M/87/15/HH

PLAN-010998

Proposal: First floor rear extension. Resubmission of M/65/15/HH.
Site: 6 Templesheen Road, Elmer, Middleton-on-Sea, PO22 6JB.
M/87/15/HH

Southern Water MapGuide Browser

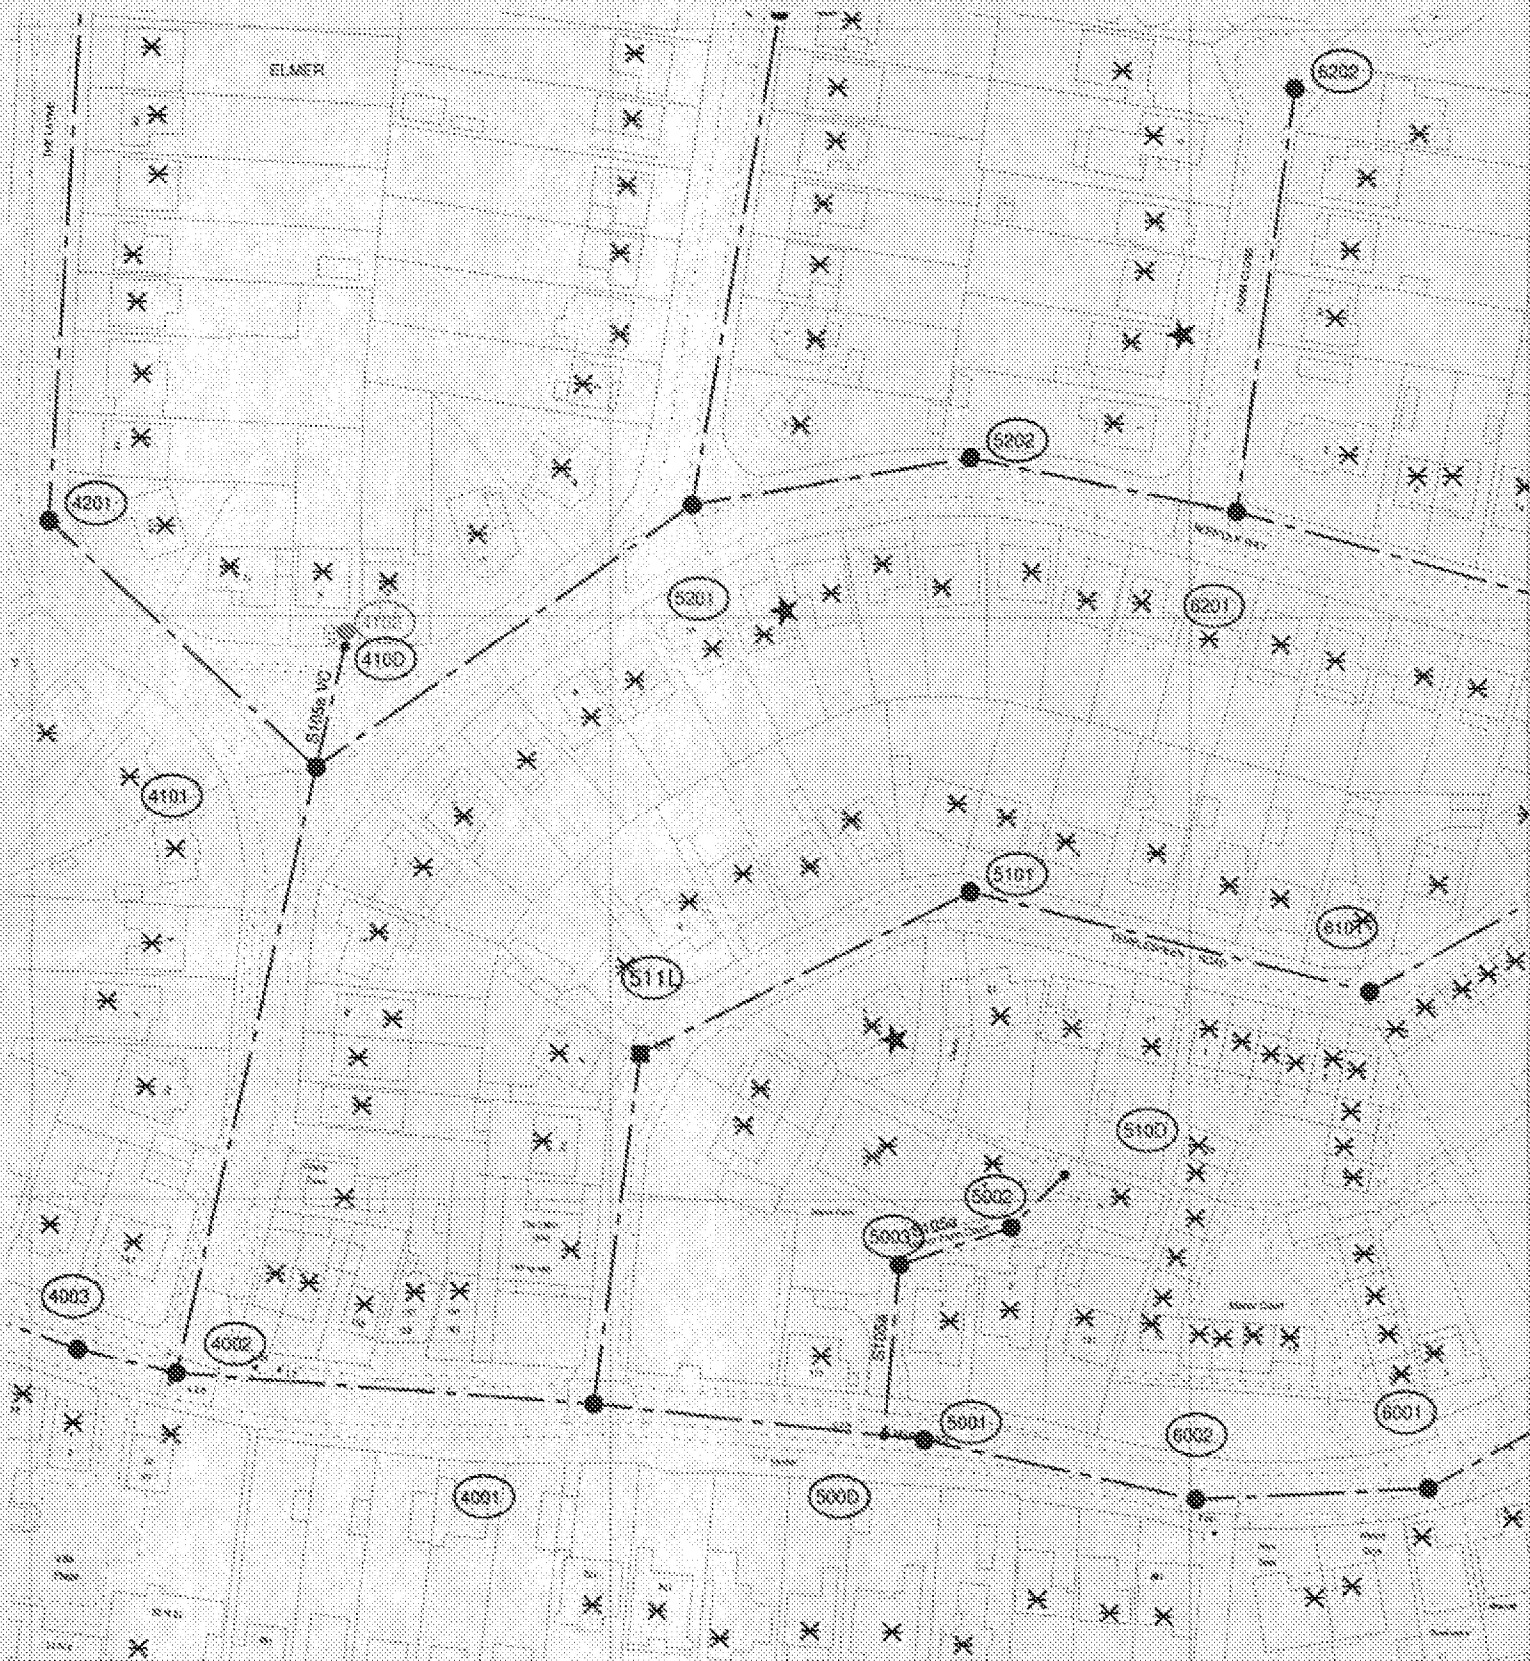
Our initial investigations indicate that there are no public surface water sewers in the area to serve this development. Alternative means of draining surface water from this development are required. This should not involve disposal to a public foul sewer.

Developer should look to protect the public sewerage system from inundation and infiltration, which contribute to flooding in unfavourable conditions.
